**SIB 31 01 02**

SERVICE ACTION: Replacement of bolt in the fork stabilizer - 31 001 02 (043)

Bulletin No: 31 001 02 (043)

Subject: Technical Action: Replacement of bolt in the fork stabilizer - F 650 Dakar models only.

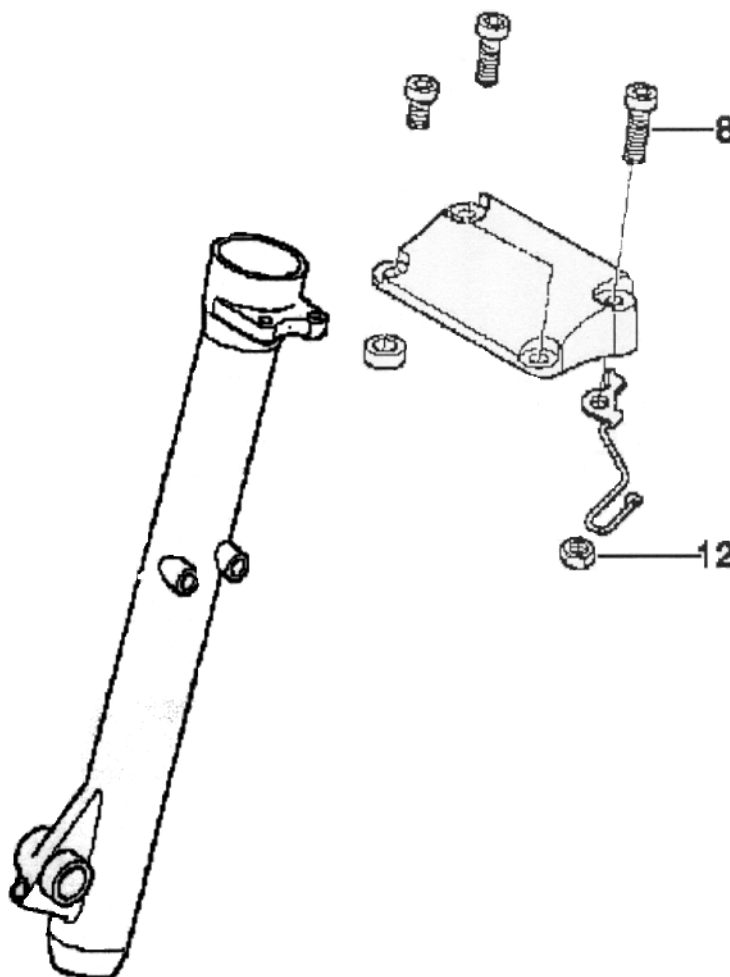
Details: We have been notified by Showa, the manufacturer of the front forks for the F 650 Dakar model, that one of the four mounting bolts, attaching the fork stabilizer to the fork legs is incorrect.

The shank on the incorrect bolt is too long and may not hold properly, even though it was installed to the correct torque.

It is possible that the brake hose holder that is held in place by this bolt may work loose over time.

Production Solution: Installation of a shorter mounting bolt. The nut of the brake hose holder is now secured with Loctite.

Service Solution: Remove the mounting bolt (#8 in the illustration below) replacing it with the M8x40 bolt included with this bulletin. Tighten this bolt to 20 Nm.

Install the brake hose holder and securing nut (#12 in the illustration below). Use Loctite 2701 and a tightening torque of 8.5 Nm for this installation.
